RE: **Approval of Plans (REV 1)**
TDOT Gibson County Maintenance Building
1248 B Manufacturers Row
Trenton, TN 38382

TFM # 21267
Project # 2023-11-09-02
County: Gibson

Revision #1 Drawing Changes

1 ELECTRICAL FIRST FLOOR - BUILD-OUT

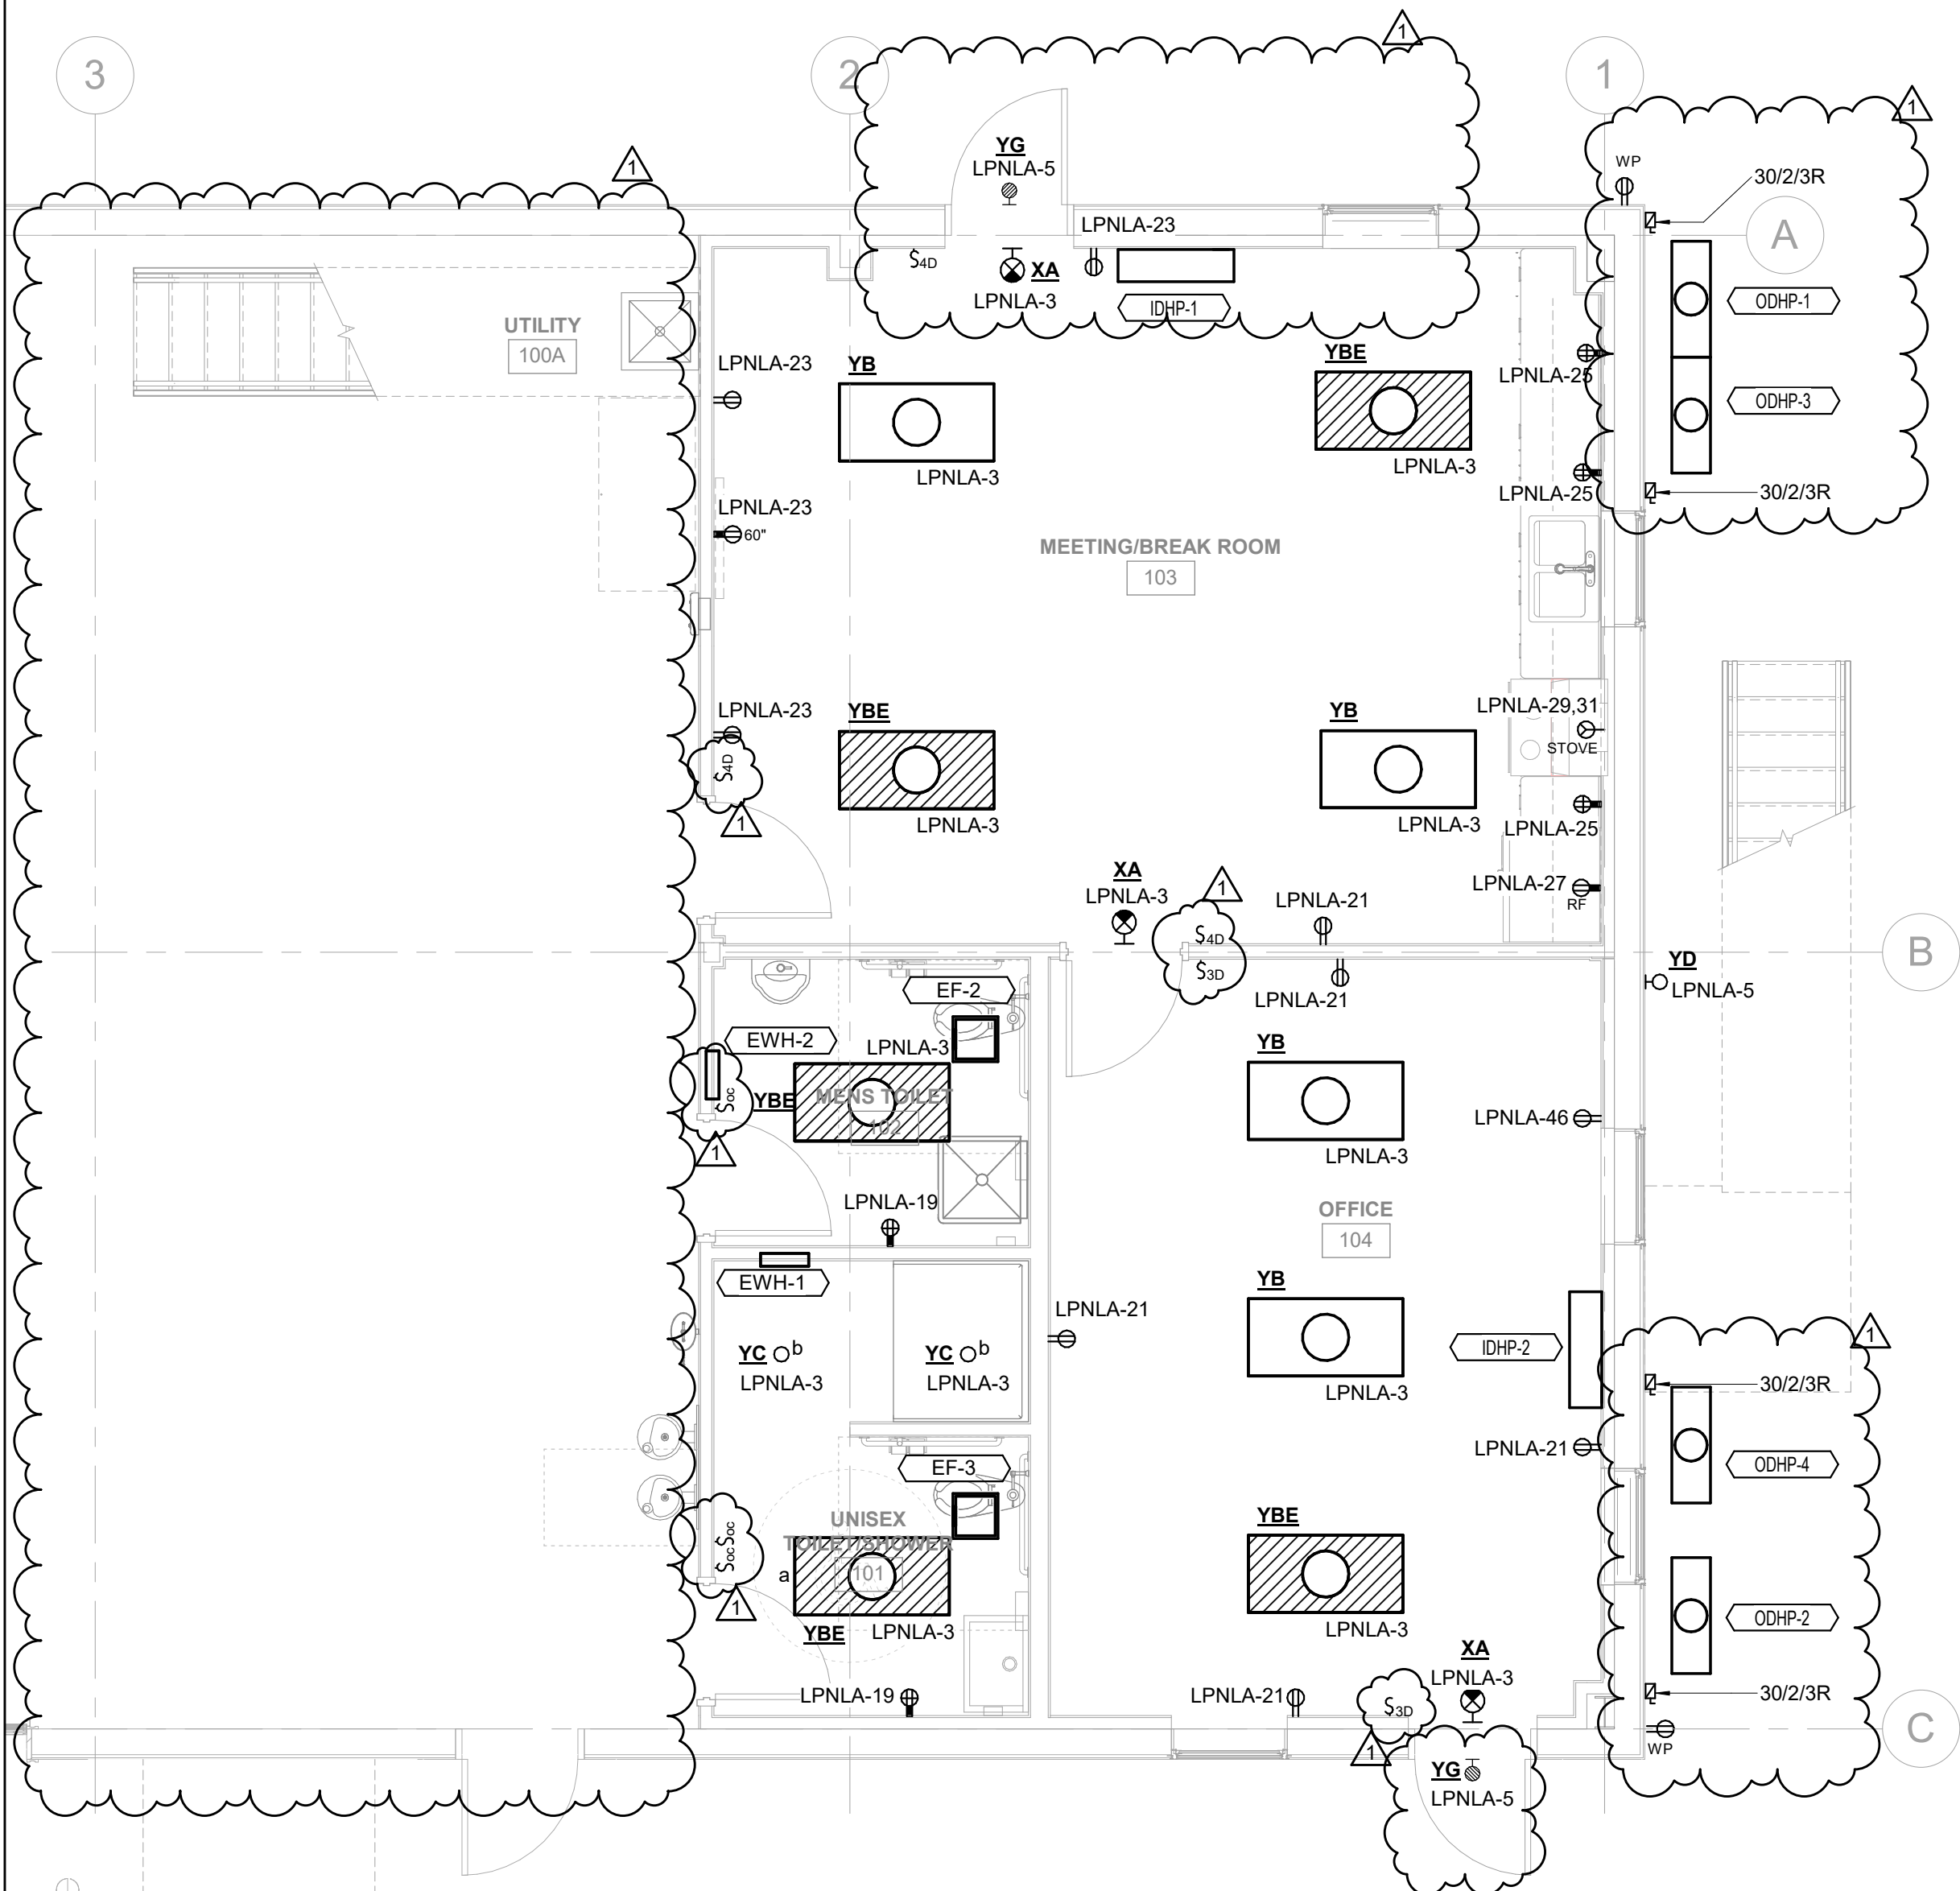
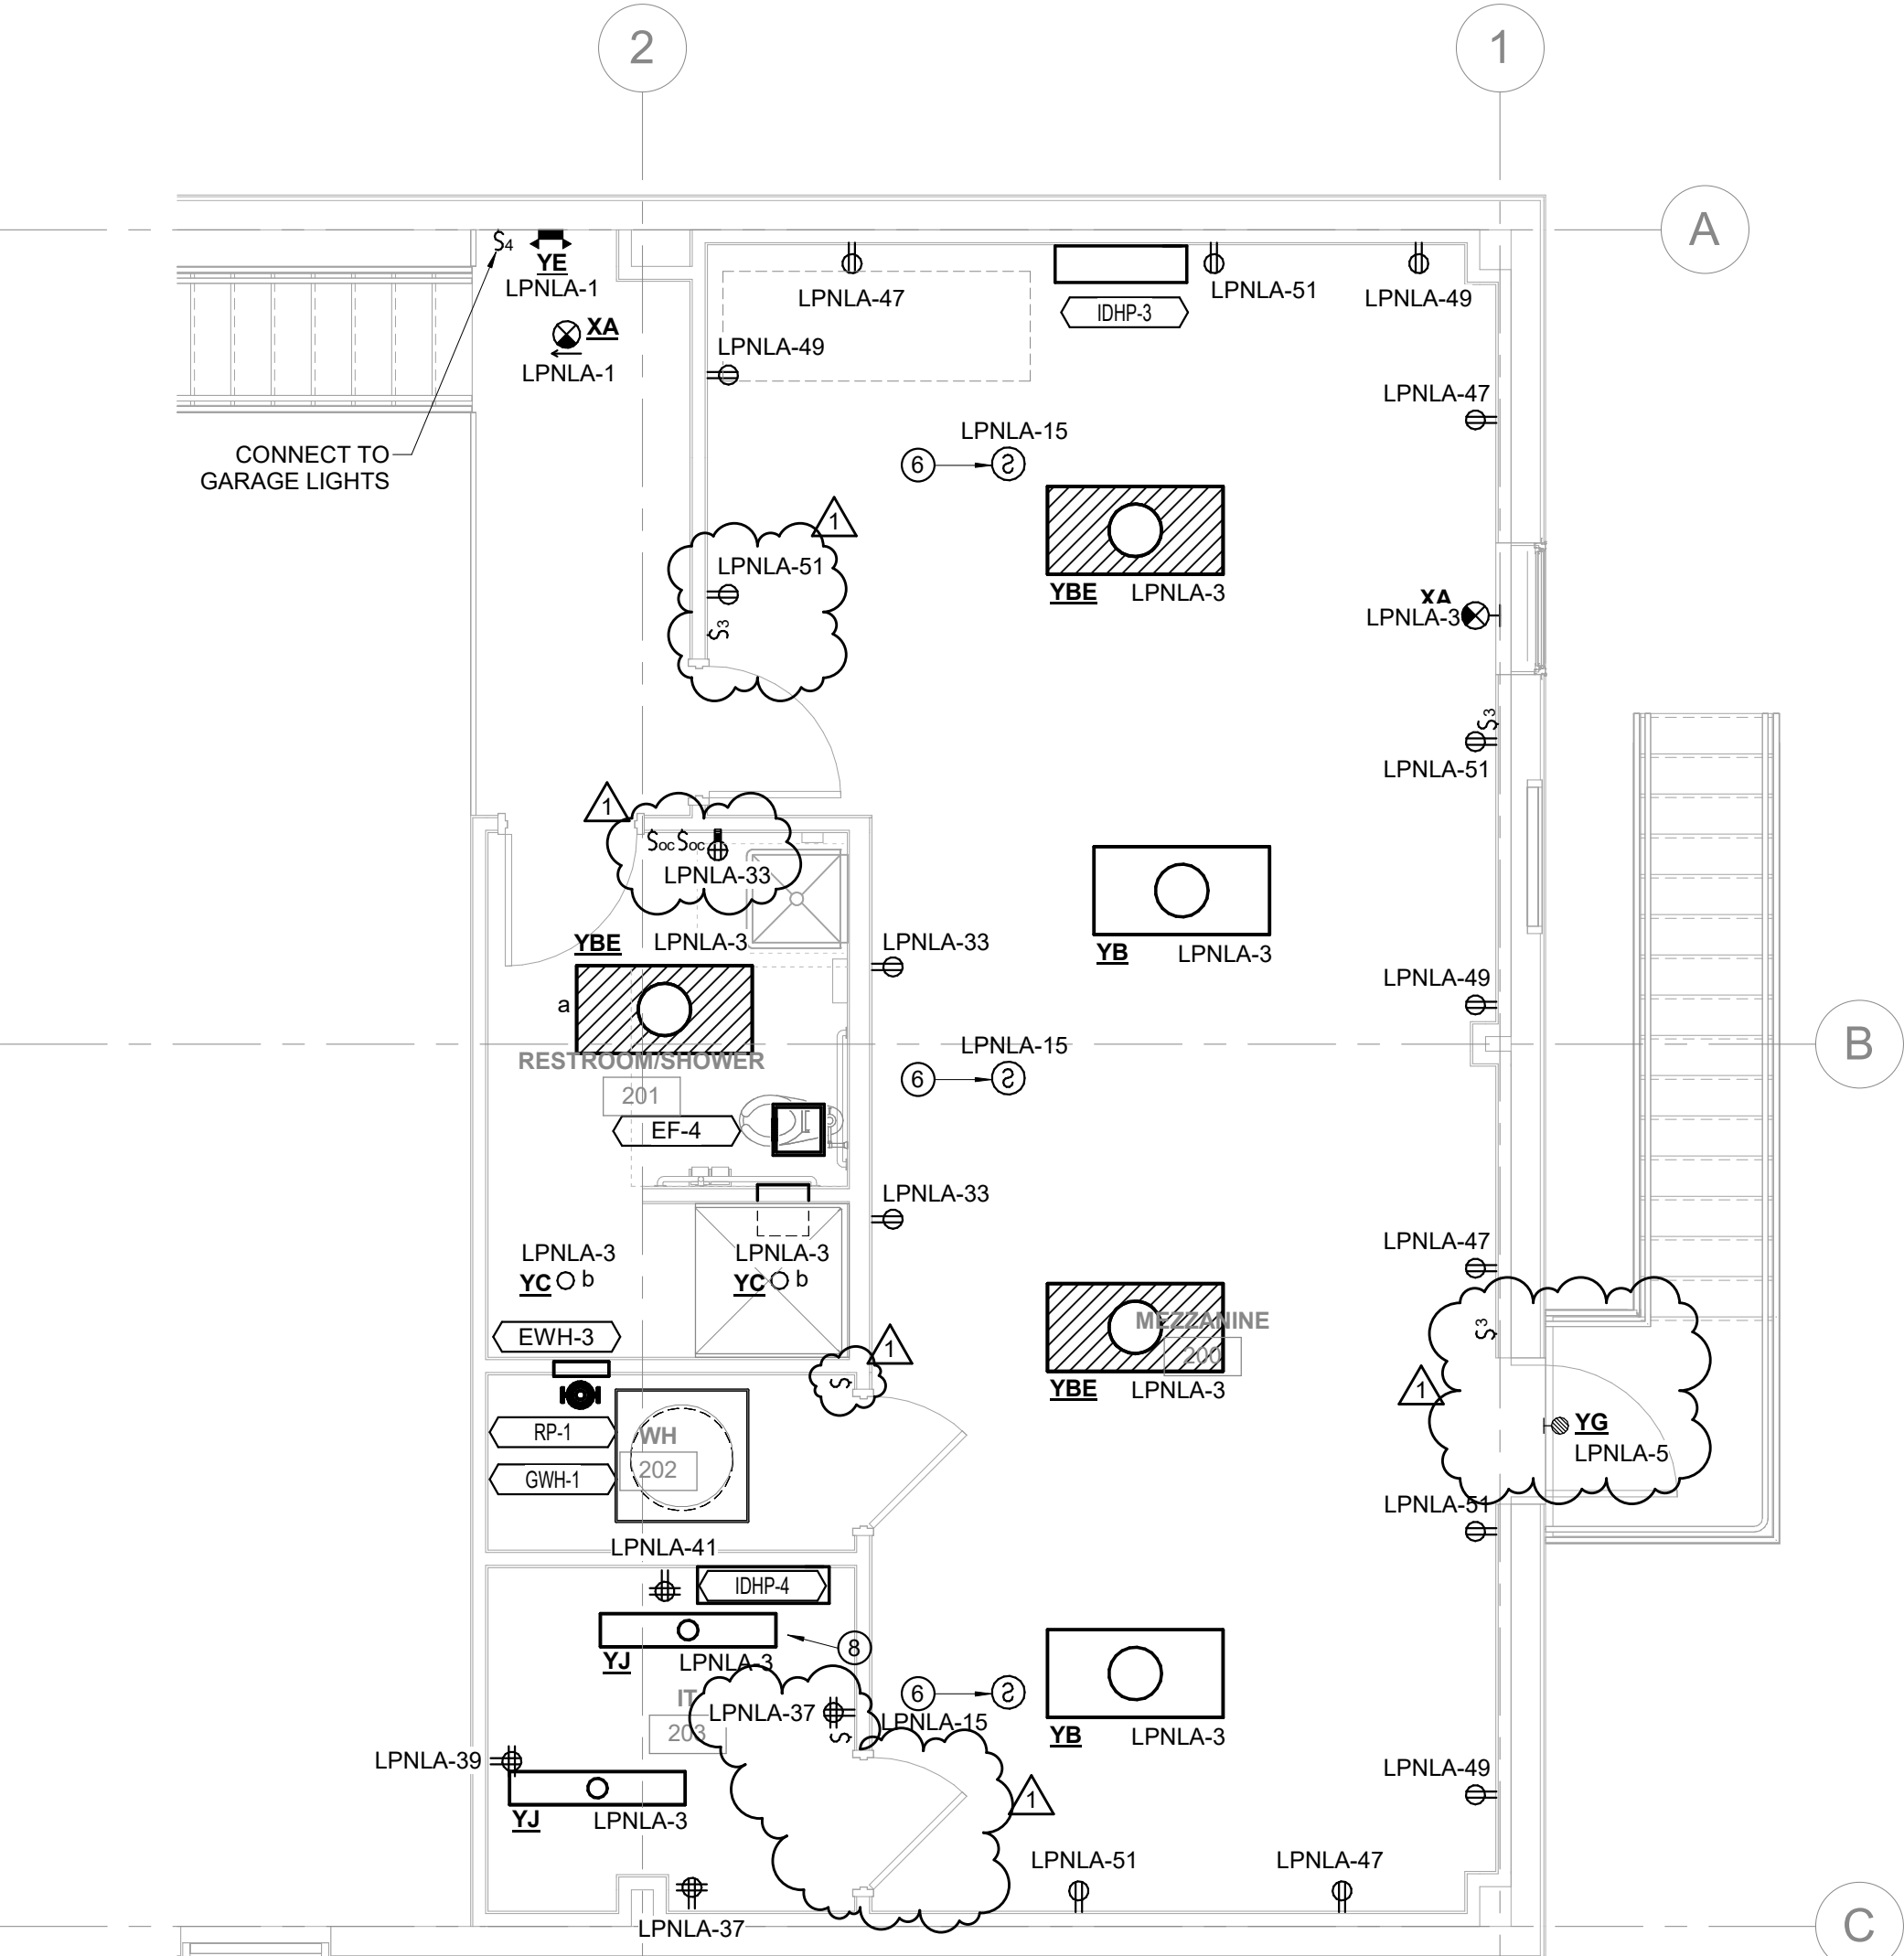
Sheet E1.1: Redundant electrical and lighting fixtures that are already shown on E1.0 were removed from the shop area, type YG lights were moved over man doors, revised location of exterior door, switches in the break room were changed to type 4-dimmer, switches in the bathroom were changed to type OC, switches in the office were changed to type 3-dimmer, maintenance receptacles and safety switches were added at exterior mechanical units, switches on the mezzanine were revised to be type 3, light type YG was moved over man door at top of stairs, switches in the water heater closet and IT room were changed to standard switches, receptacles were added in the IT room and upstairs shower/restroom.
